Informal Document No. **GRRF-62-38**

**Comments from India on the GTR for Passenger Vehicle Tyres
under formulation by the Working Group on Tyres**

Fig. 1

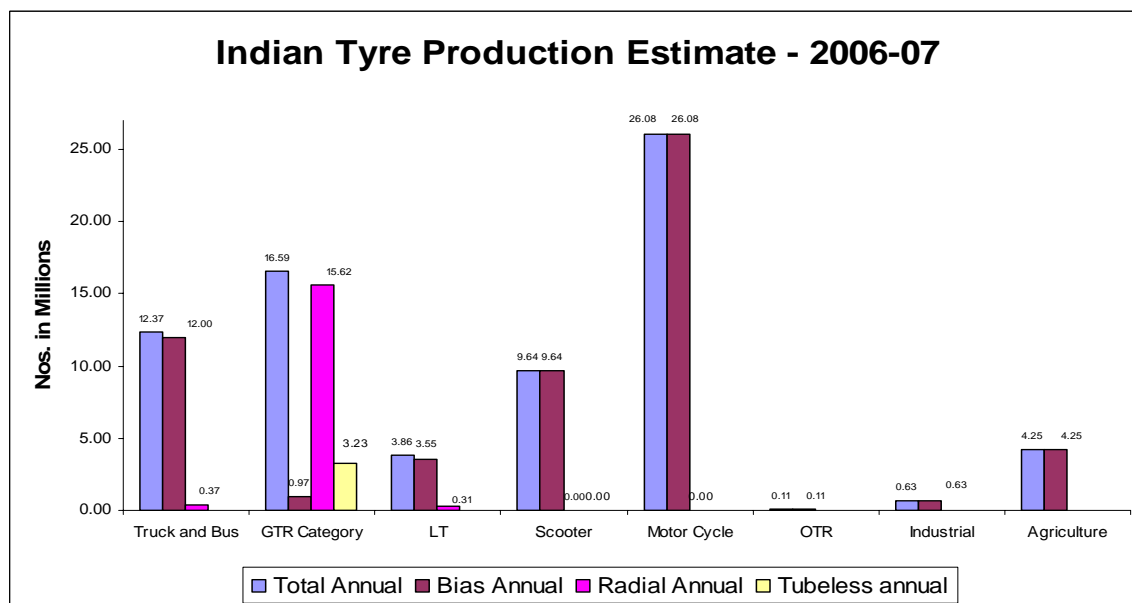
India has large number of Bias tyres still manufactured. The total tyre production (including commercial, passenger, scooter/motor cycle and agricultural vehicles) is estimated to be about 74 million. Out of which, 57 million are Bias ply tyres for the Indian tyre production estimated for the year 2006-07. In passenger segment (which includes LT category also for less than 1250 kg load capacity), the Bias production is about 1.0 million and Radial 15.6 million. The production of Bias tyres is likely to continue for many years (and may even slightly grow in certain applications like non -highway tyres). Bias tyres also constitute a significant part of tyre exports originating from India.

Among the 15.6 million radial tyres produced in the passenger category, only about 3.2 million are in the tubeless category and remaining 12.4 million in tube type. The tubeless production is growing, but complete changeover would take time.

As Bias tyre production and Tube type tyre production is expected to continue in India for more than a decade, these categories need to be addressed in the GTR. This will also help in including some other specific items pertaining to Bias tyres.

Fig. 3

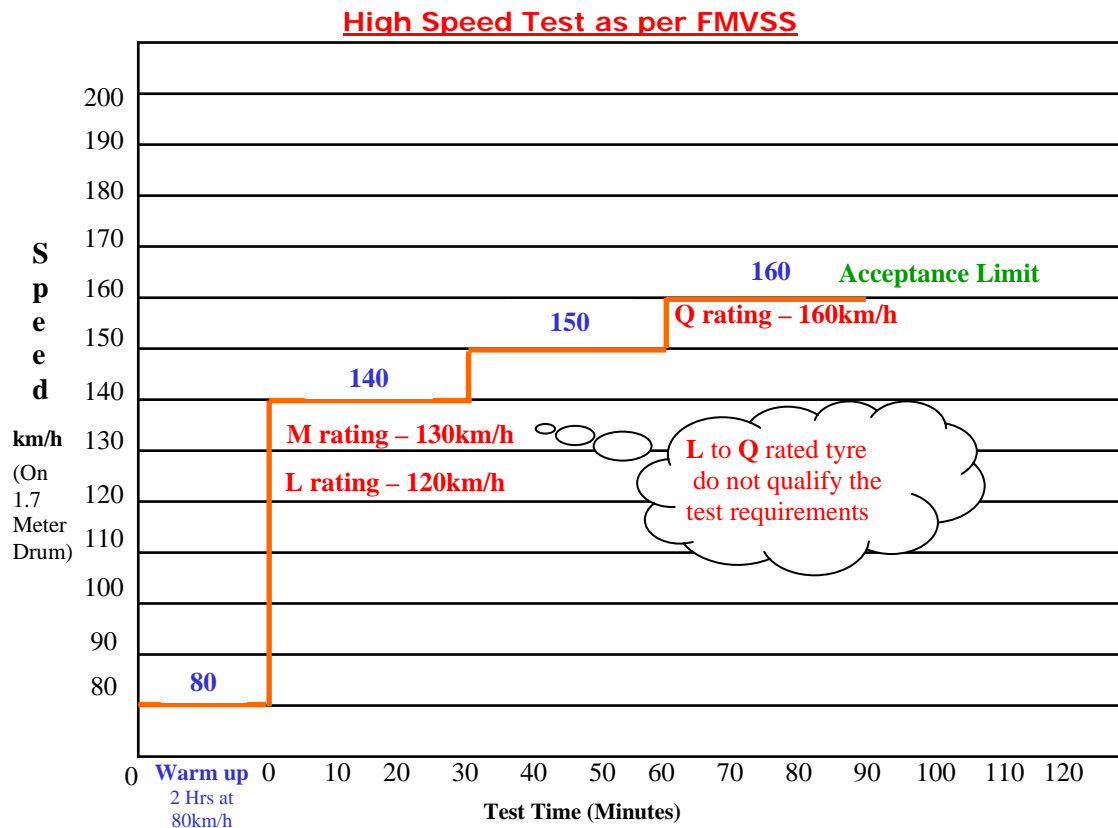
Based on the existing running sizes used in India, there is a group of sizes which have speed ratings from "L" to "Q" (which is 120km/h to 160km/h). This group has max. load capacity of less than 1250 kg, hence does qualify under category of tyres being covered under GTR.

This group, by virtue of its speed rating range, cannot be tested as per FMVSS 139.

The tests applicable to such types of LT tyres needs to be clearly defined and addressed . For example such tyres may not need a high speed test but can have step load test like ECE54.
